MAJOR PROJECT ASSESSMENT: *Charbon Coal Project 08_0211*

Director-General's
Environmental Assessment Report
Section 75I of the
Environmental Planning & Assessment Act 1979

September 2010

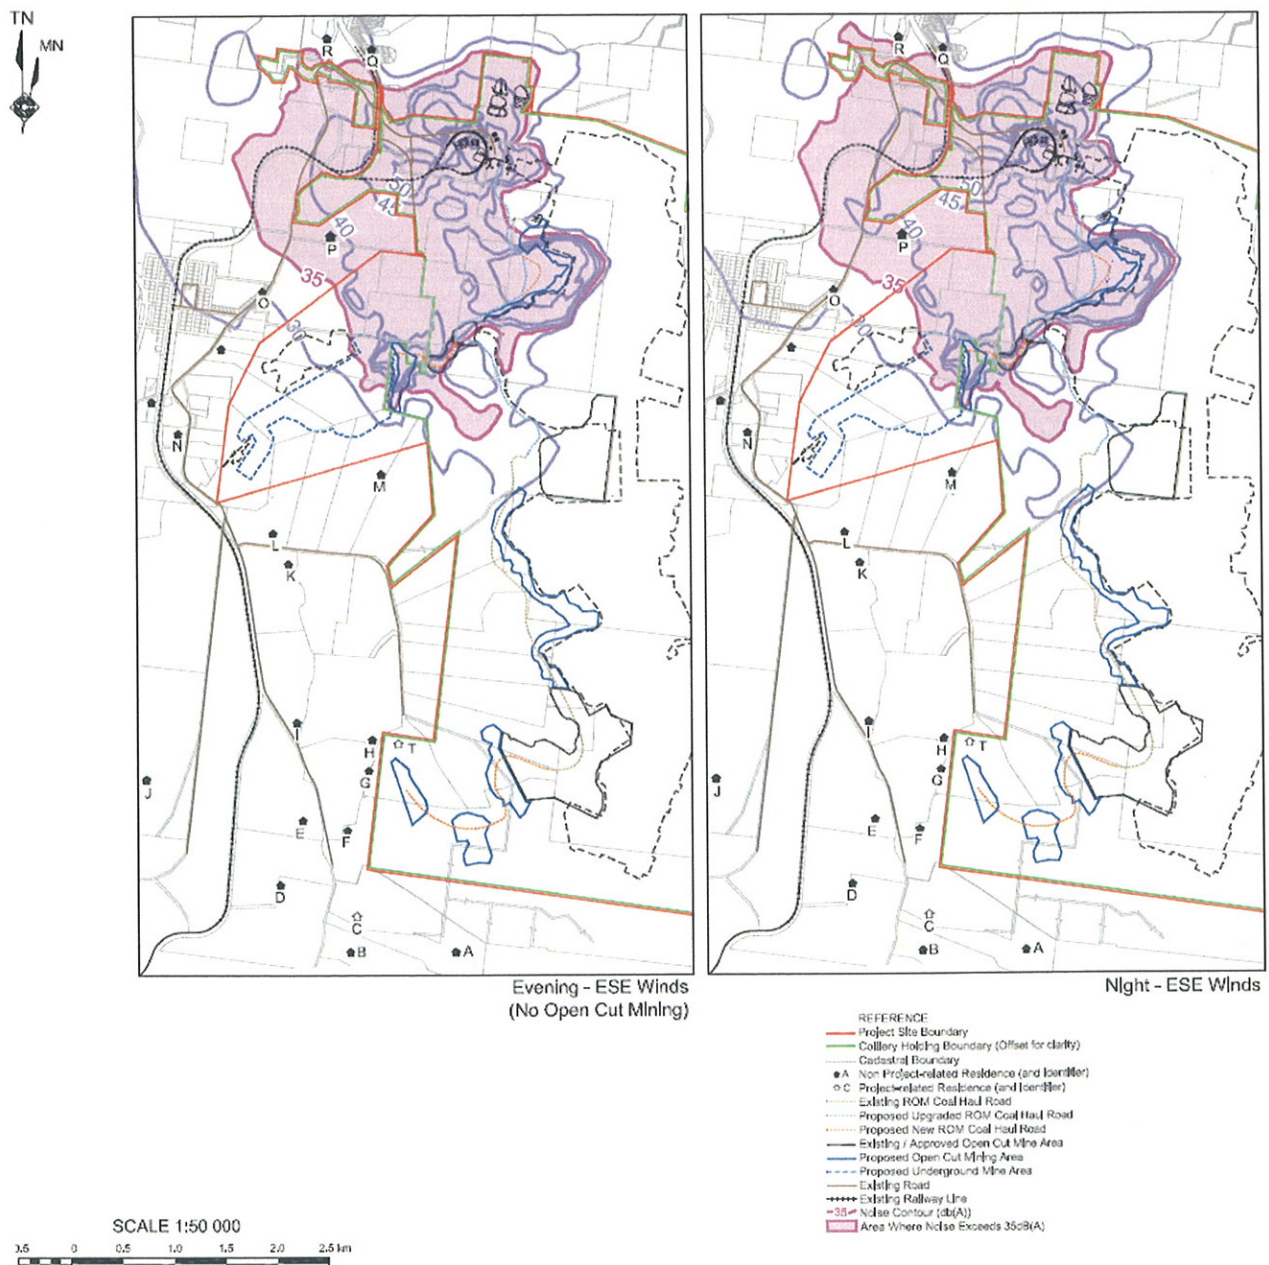
The predicted exceedances of project specific noise levels (PSNLs) are summarised in Table 2, while Figure 3 depicts noise impacts for the worst-case operational scenario. Both DECCW and the Department consider the predictions to be reasonable. Charbon originally proposed to undertake open cut operations until 10 pm in all seasons except Autumn. This was of concern to the Department and DECCW as significant exceedances of PSNLs were predicted to occur if open cut operations took place during noise enhancing wind conditions and there was some uncertainty about the occurrence of such adverse weather conditions during Summer evening periods, due to limited background monitoring. To correct this uncertainty, the Department requested an investigation of the occurrence of noise enhancing winds using monitoring data from the on-site meteorological station. This investigation confirmed that noise-enhancing east-south-east winds are a feature of the site during the evening periods of Autumn months and after 8 pm in Summer

The NIA suggested that minor exceedances of the PSNL criteria at property M would occur during the later years of the project, primarily due to activities in the 8 Trunk and Central open cut pits, and moderate exceedances of the criteria at property P during all years of the project under adverse weather conditions, principally due to the continued operations of the CHPP and Central open cut (refer Table 2 and Figure 3).

Despite extensive noise mitigation works being applied to mining equipment, noise impacts for residences located down wind are greatly increased when noise-enhancing winds (east-south-east) occur. The NIA, in accordance with DECCW's *Industrial Noise Policy 2000*, has considered the noise-enhancing winds to be a feature of the site when they occur more than 30% of the time. Charbon has subsequently committed to cease open cut operations during these times. However, these noise-enhancing winds could occur (albeit at less frequency) during open cut operations for any period. When noise-enhancing winds occur in conjunction with open cut operations, the predicted noise impacts are significant for a number of nearby residences.

The Department has recommended conditions of approval to set noise impact assessment criteria as:

- 39 dB(A) for evening and night periods at residence P;
- 36 and 37 dB(A) for day and evening periods respectively at residence M;
- 38 dB(A) for all time periods at residence Q and other residences within 150 m of this location; and
- 35 dB(A) for all other residences and for all other time periods at residences M and P.

Figure 4: Vegetation Communities and Proposed Offsets

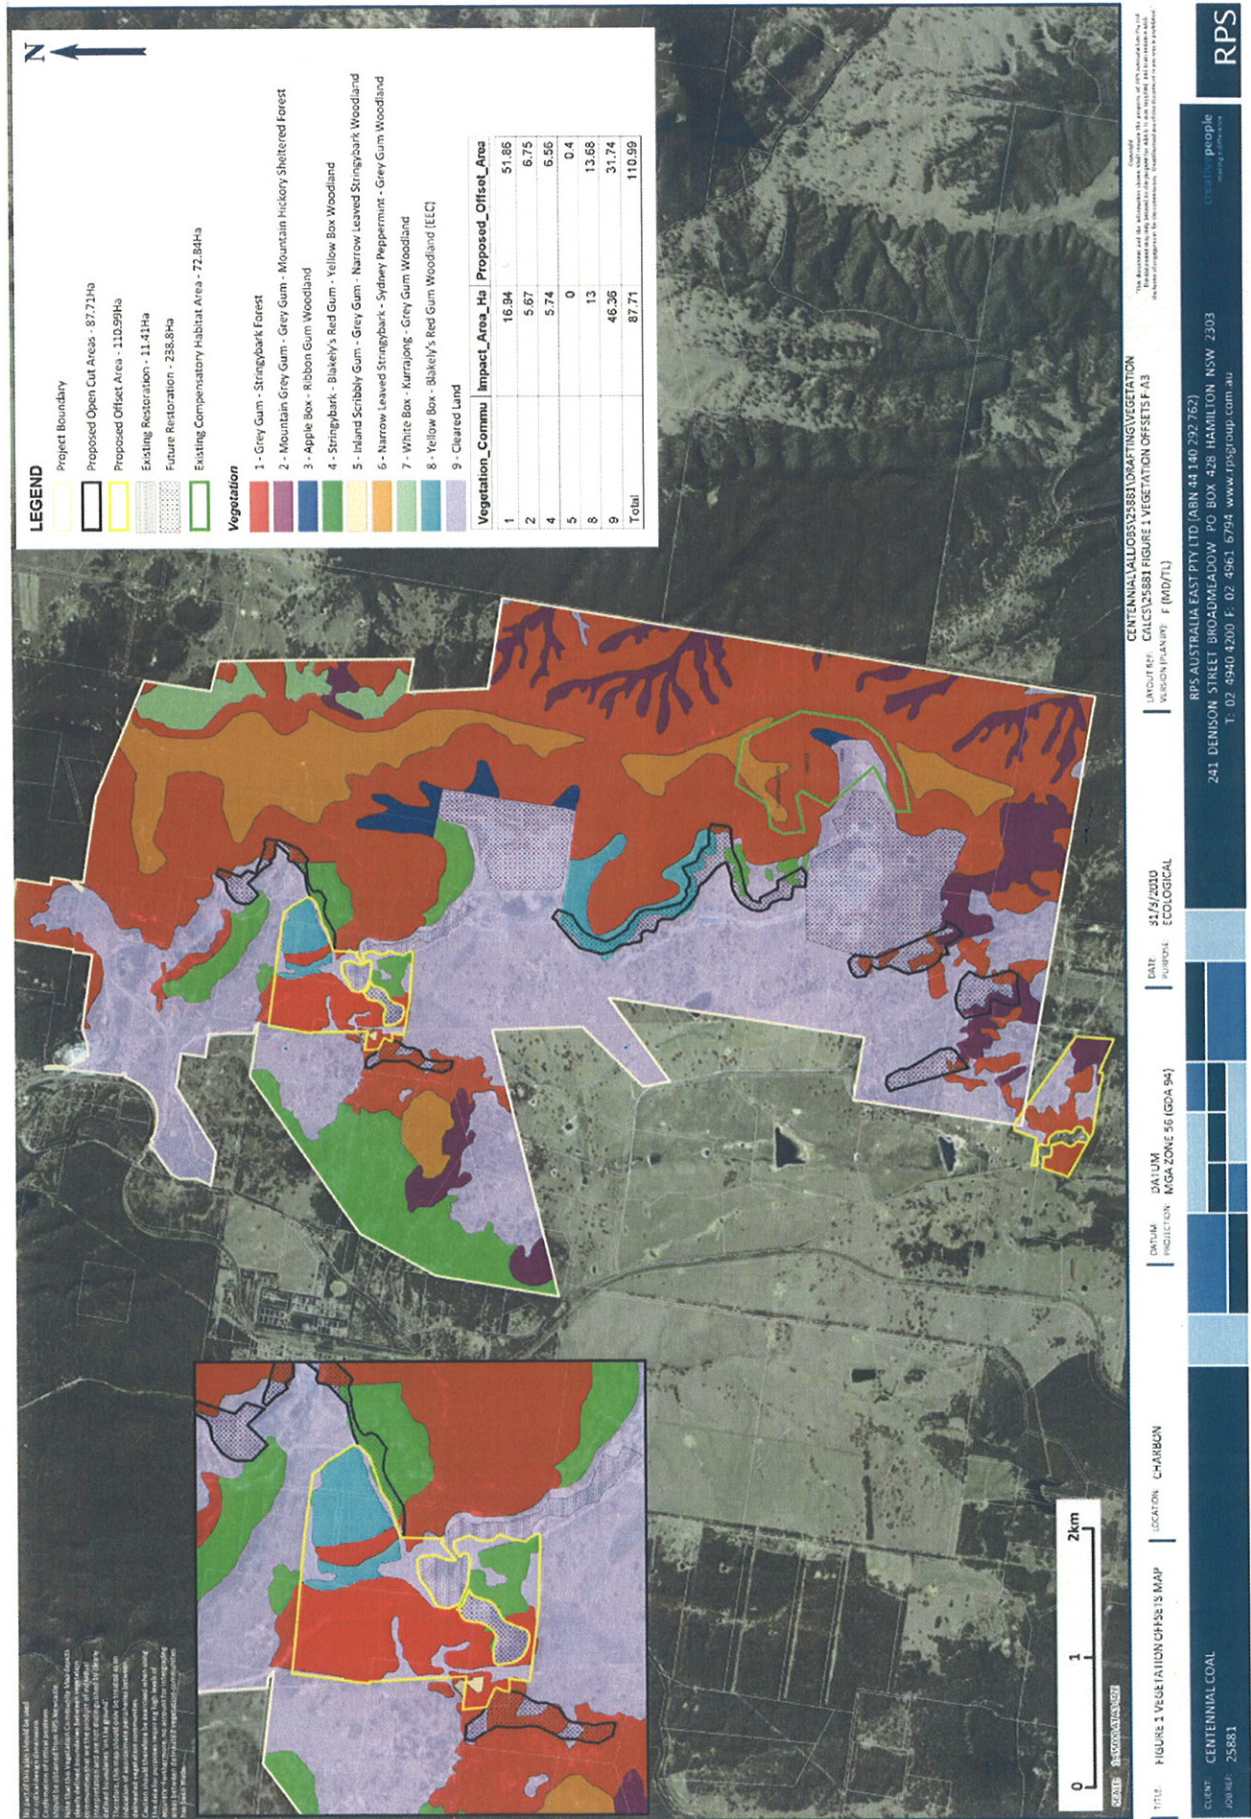
One EEC, *White Box-Yellow Box-Blakely's Red Gum Grassy Woodland* ("White Box EEC"), and one threatened flora species, *Eucalyptus cannonii* (Capertee Stringybark), listed under the *Threatened Species Conservation Act 1995* (TSC Act) were recorded on-site. The White Box EEC is also listed under the Commonwealth EPBC Act as the critically endangered *White Box-Yellow Box-Blakely's Red Gum Grassy Woodland and Derived Native Grassland* ecological community (see Figure 4).

The project would disturb 13 of 26 ha of the White Box EEC existing within the project area. The flora assessment determined that this may have a significant impact on this vegetation community. Subsequently DECCW and the Department determined that in order to improve or maintain biodiversity outcomes, a biodiversity offset would be required (see below).

The Department has recommended conditions of approval that would require Charbon to acquire the areas listed in Table 3 prior to 31 December 2012 or the clearing of any EEC vegetation, whichever is the sooner, and to make suitable arrangements to provide appropriate long-term security for the offset areas to the satisfaction of the Director-General.

Figure 5: Location of threatened fauna species records.

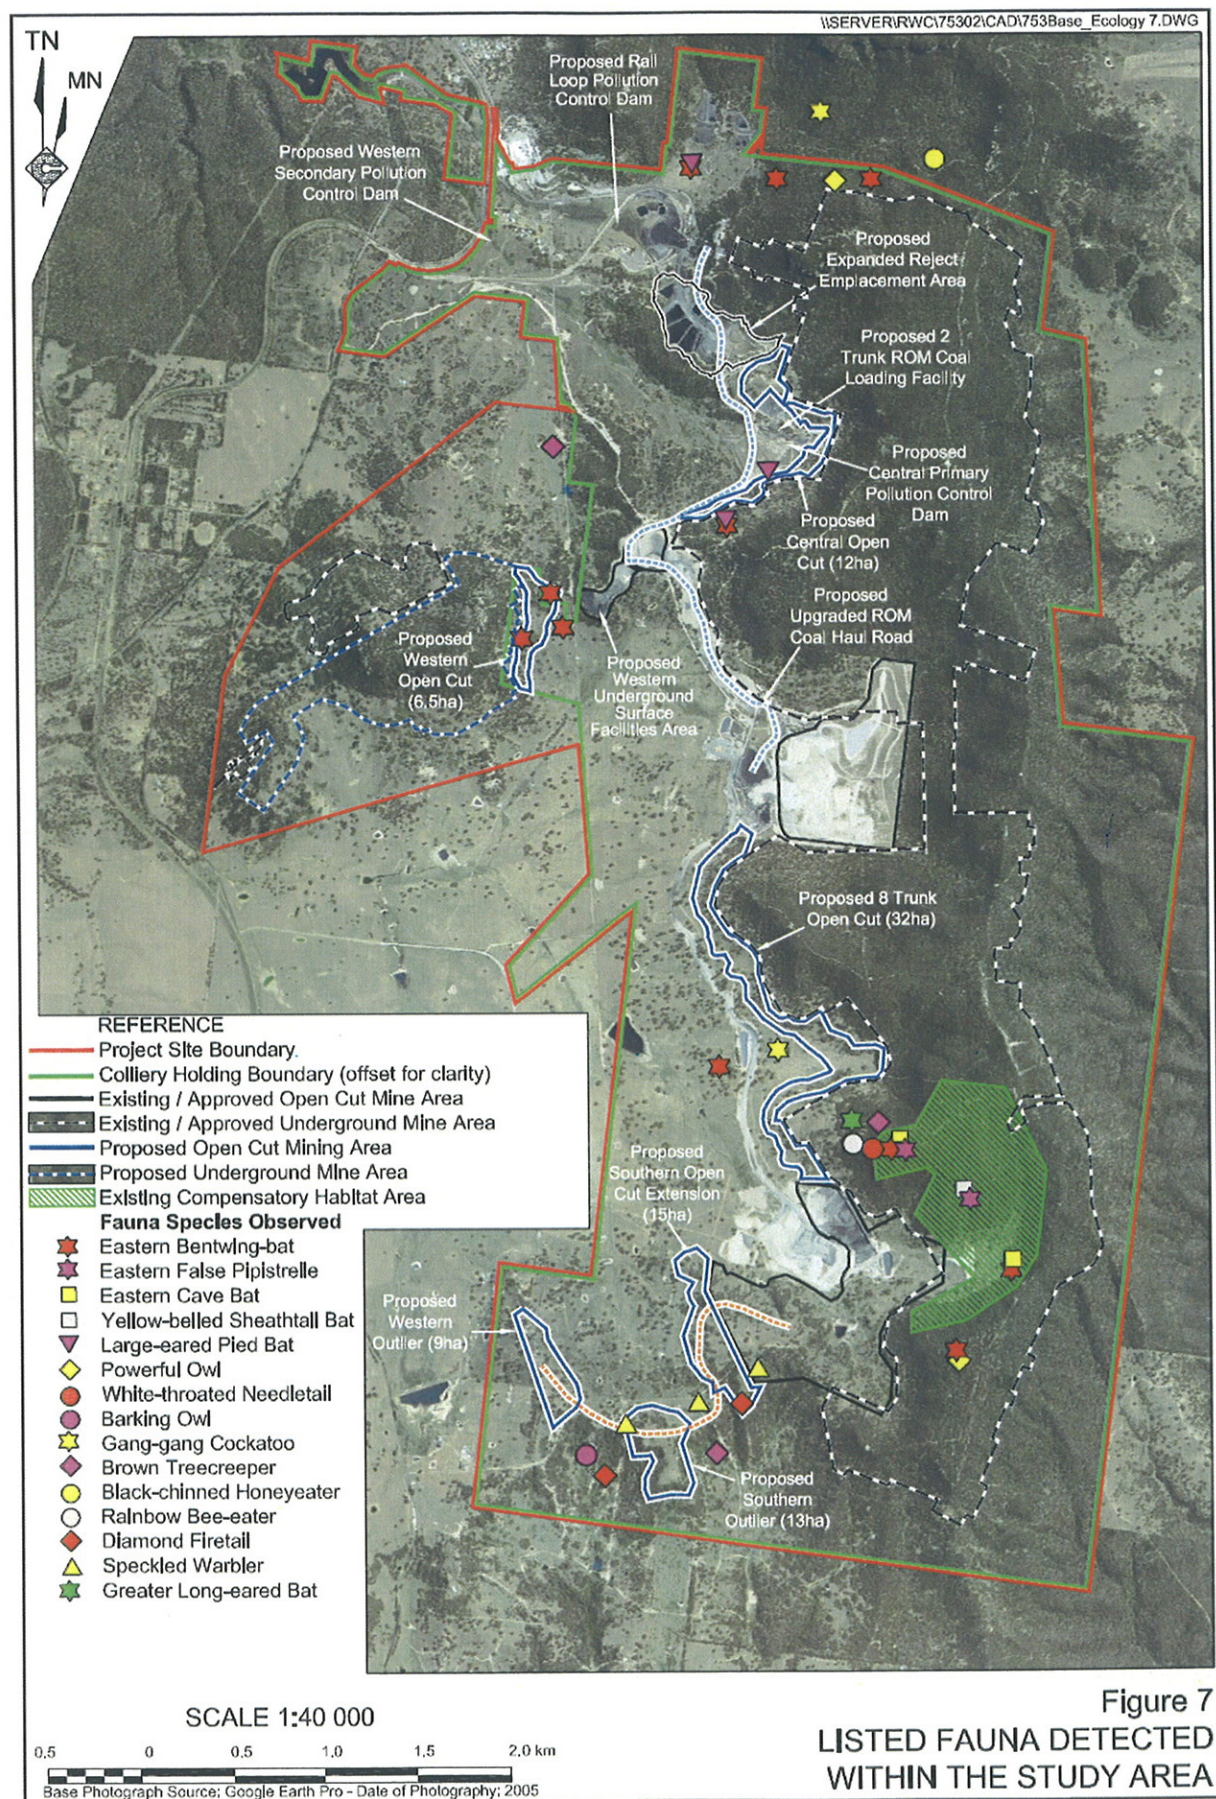
Fauna surveys identified 140 fauna species on the site. Of these, 16 species are listed under the TSC Act (refer Figure 5):

However, only four threatened fauna species were observed in areas that would be disturbed –the Diamond Firetail, Eastern Bentwing-bat, Large-eared Pied Bat and Speckled Warbler (refer Figure 5).

The project would remove habitat for 10 of the threatened fauna species likely to occur on-site. Charbon has committed to preparing a Fauna Management Plan containing measures to minimise individual injury/mortality rates among the identified threatened fauna species. These measures include pre-marking of all habitat structures for re-use, gradual disturbance and slow-felling, and the presence of an ecologist to capture and relocate individuals that do not move into adjacent areas on their own. Additionally, Charbon has committed to revegetating all open cut pits with endemic flora species.

Figure 6: Predicted Incremental 24-hour Average PM_{10} Concentrations ($\mu g/m^3$) Year 4 Operations.

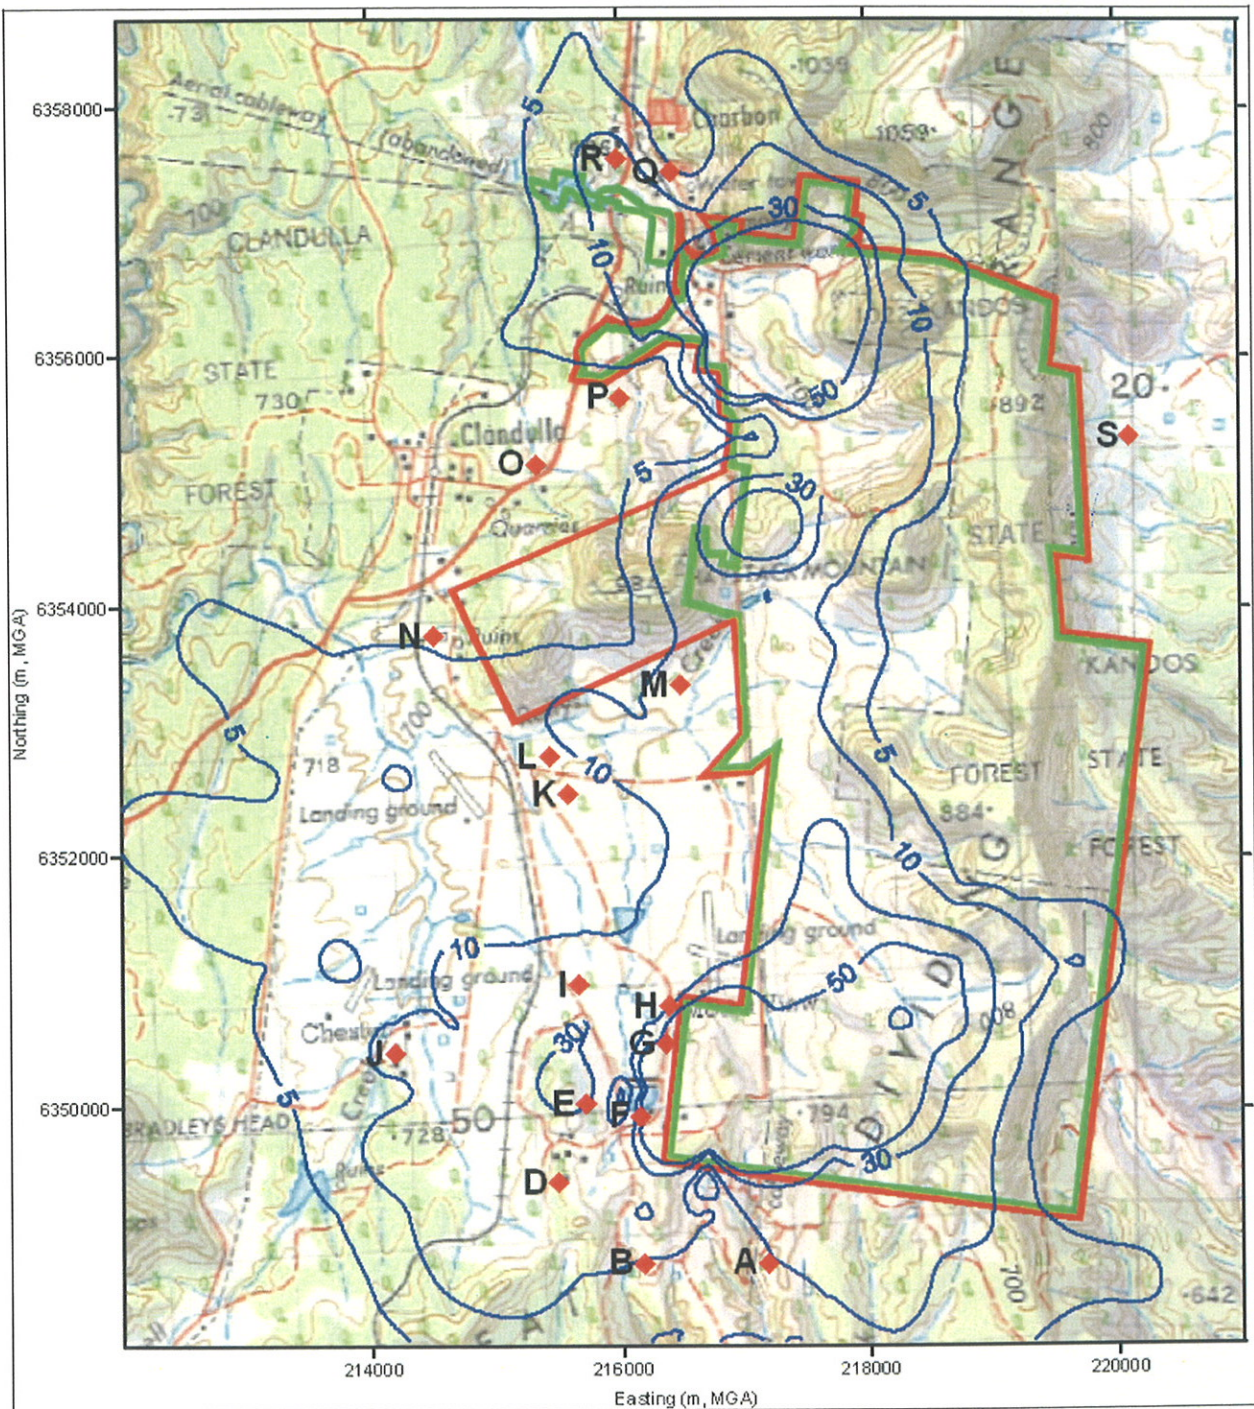
However, residence G is predicted to experience exceedances of the 24-hour PM₁₀ air quality cumulative criteria for up to 51 days of the year during Year 4 operations. These exceedances are attributed to open cut mining in the Western Outlier, which would take 6-12 months to complete. Residence G is also predicted to experience exceedances during Year 4 of 1.1 g/m²/month over the incremental and total dust deposition criteria of 2.0 and 4.0 g/m²/month, respectively. These predictions are 'worst-case', however, they are significant.

The Department also notes that residences F and H are located very close to residence G, however, the AQIA does not predict any significant exceedances at them (see Figure 6). The contours separating 50 µg/m³ and 30 µg/m³ 24 hour concentrations are very close in this location, and the Department is concerned to ensure that air quality management at each of these locations minimises potential dust impacts.

The Department has therefore recommended conditions to ensure that Charbon prepares an Air Quality Management Plan to be submitted and approved prior to works commencing in the Western Outlier. The Management Plan would include a combination of real-time monitors (to monitor impacts during mining operations) including high-volume samplers and dust deposition gauges to monitor dust emissions. Additionally, the Plan would include protocols for review of real-time data to ensure that operations are relocated, modified and/or stopped to achieve compliance with the relevant air quality criteria at residence G and other nearby affected residences. The Department believes the implementation of this Management Plan would ensure activities in the Western Outlier would be effectively managed to ensure air quality criteria are met, or if this is not possible, any exceedances that may occur would be quickly identified and corrective action taken. The Department has also recommended conditions that would allow the owner of residence G or any other affected residence to request attenuation works at their property, and if monitoring confirms that significant and systemic exceedances are occurring, then request the acquisition of their property.
